## ADDENDUM NUMBER ONE

### JACKSBORO SQUARE SITE IMPROVEMENTS EIKON Project #230235

April 25, 2024

ELECTRICAL SITE  
PLAN - LIGHTING

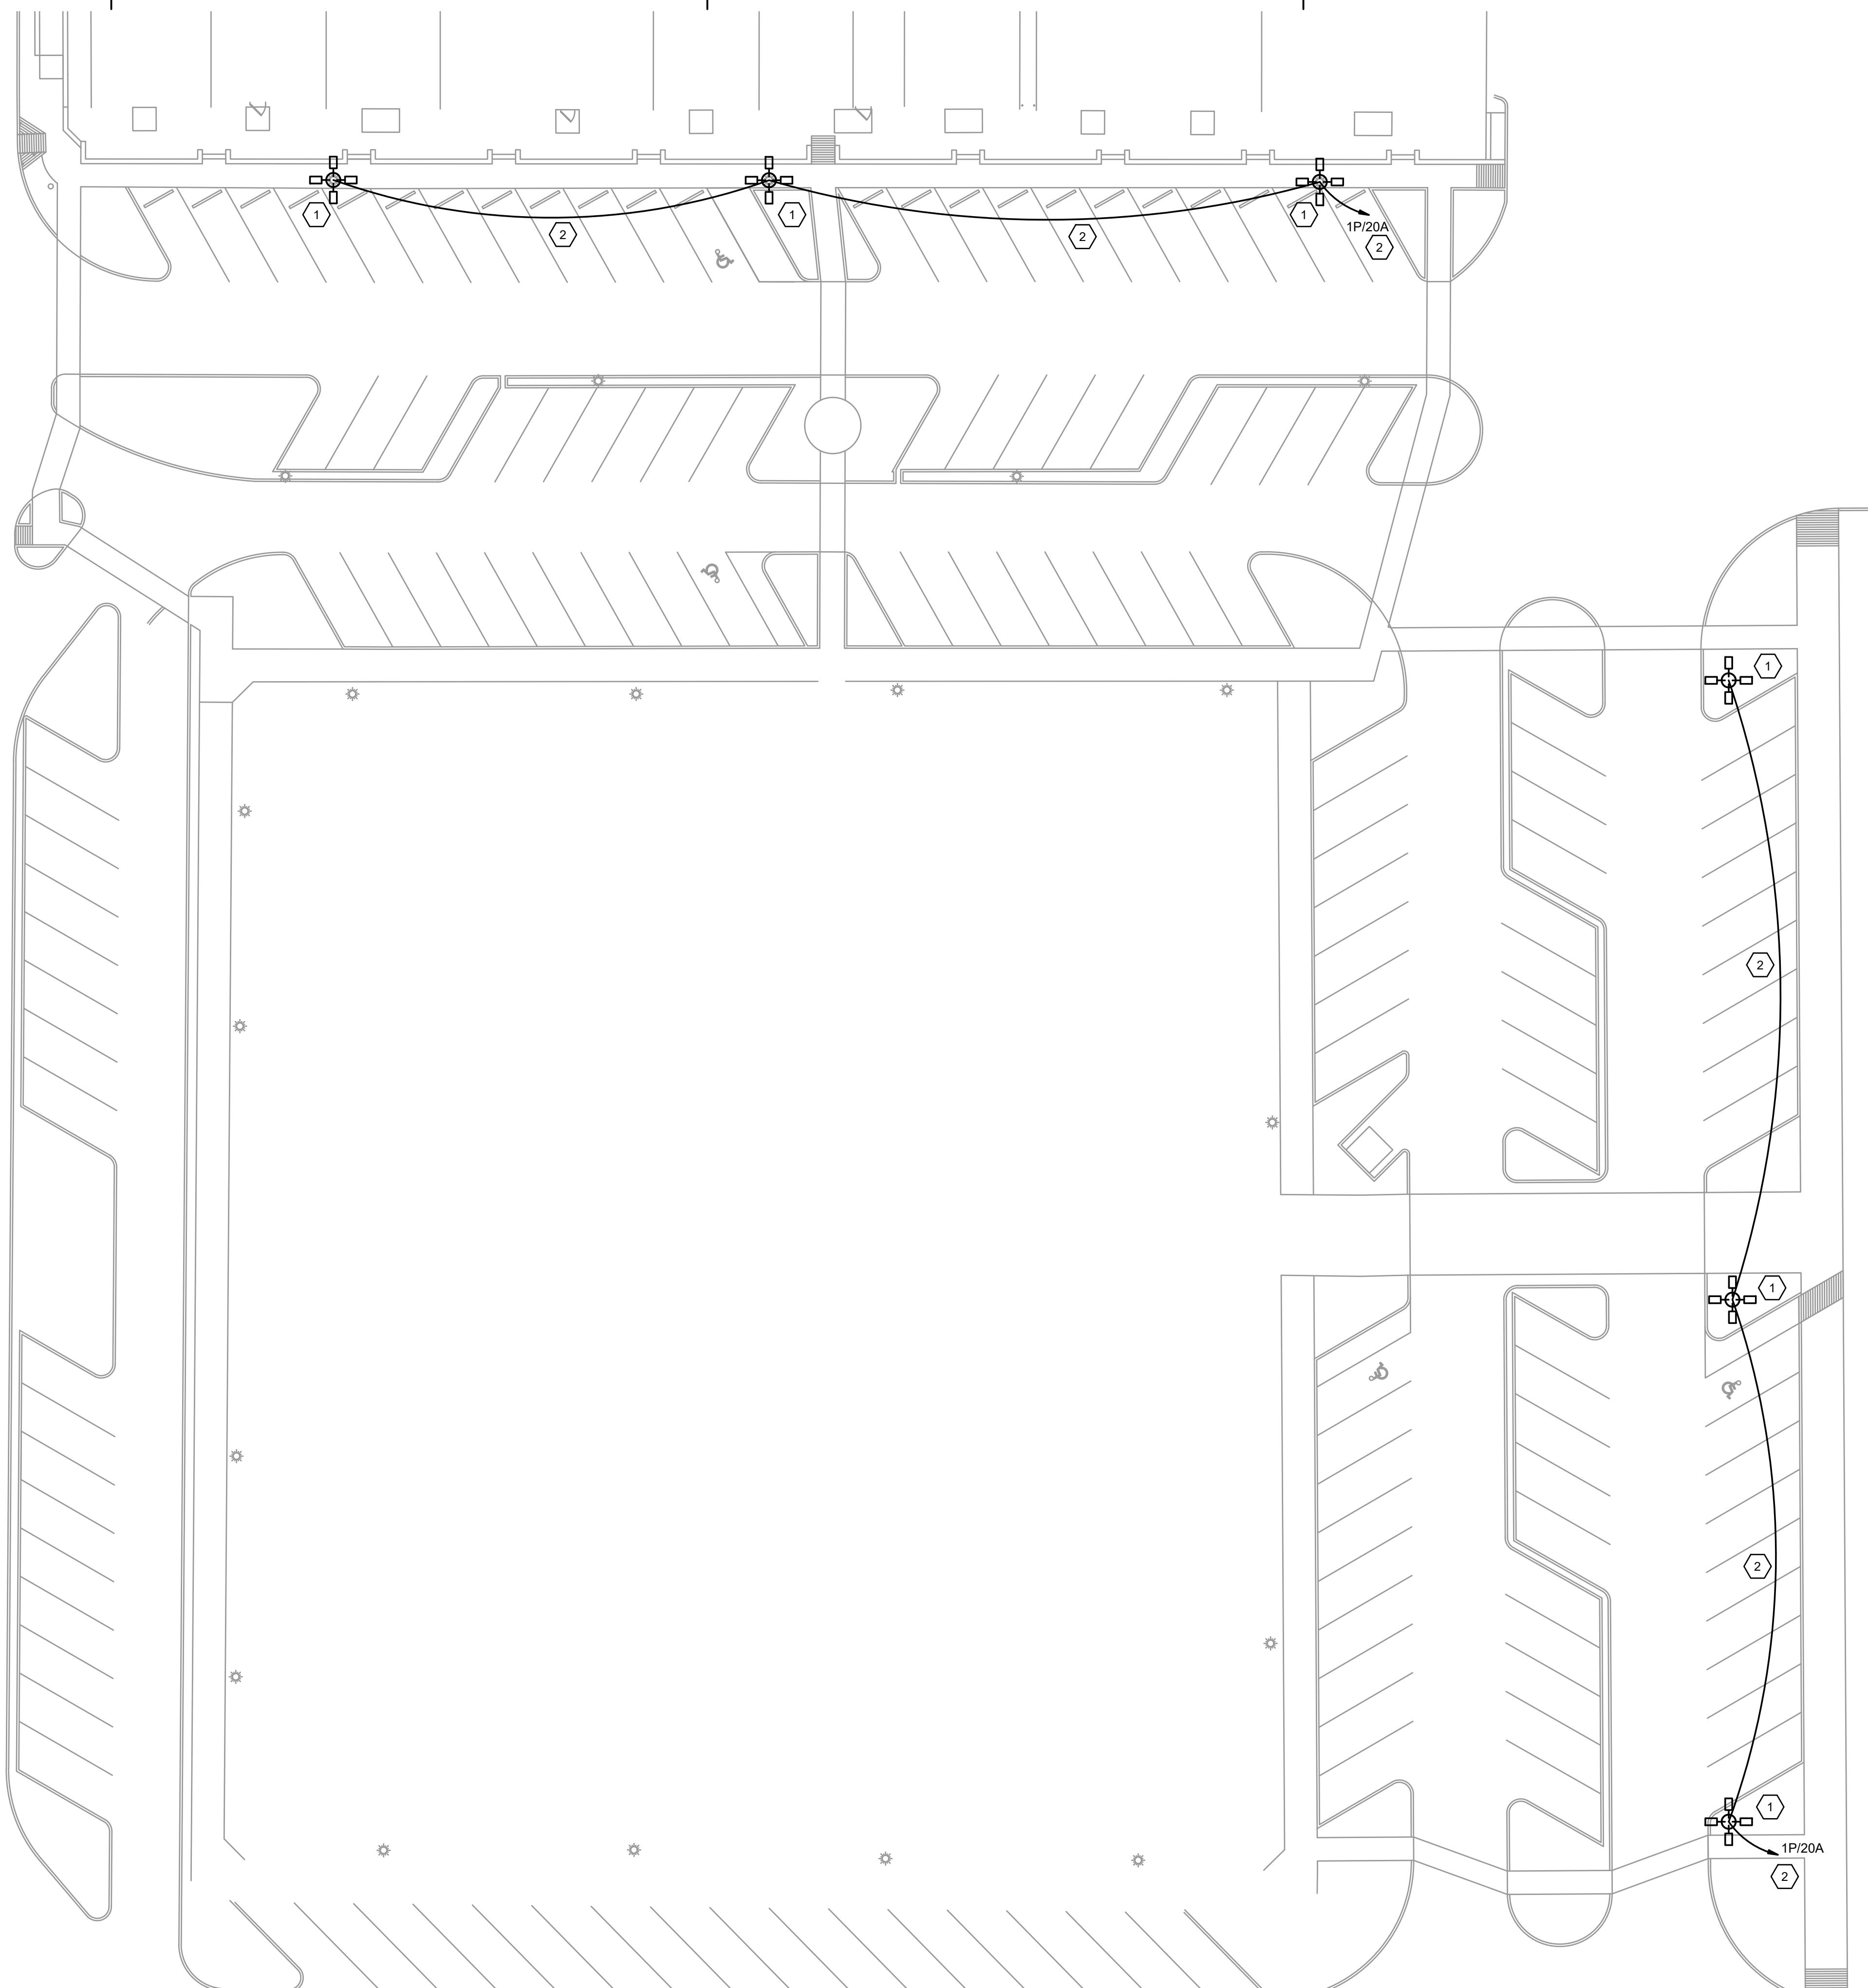
- B. Can I request the electrical sheets/details and elevations for the street lamps that are outlined as an alternate
  - a. *Response: Please see attached sheet E1.1*

① NEW LIGHT FIXTURE AND POLE BASIS OF DESIGN (TYPICAL OF 6):  
 POLES: SPRING CITY 'WASHINGTON' APSWSH-17 12.00-E5-TN2.88 5.00-CU  
 ARMS: SPRING CITY 'PAWTUCKET' AARPWK-5X-15.25-TN  
 FIXTURES: SPRING CITY 'WILLIAM AND MARY' ALMVNM-LE-EVX-CND-YW18-CU  
 COLOR, FINISH, ETC. SHALL BE VERIFIED WITH ARCHITECT AND CITY REPRESENTATIVE.

② PROVIDE NEW 120V 20A CONDUIT AND FEEDER UNDERGROUND TO NEW POLES AS SHOWN. VERIFY AVAILABILITY, LOCATION, SPACE, AND CAPACITY OF EXISTING ELECTRICAL SERVICE PRIOR TO BID, DEMOLITION, AND CONSTRUCTION.
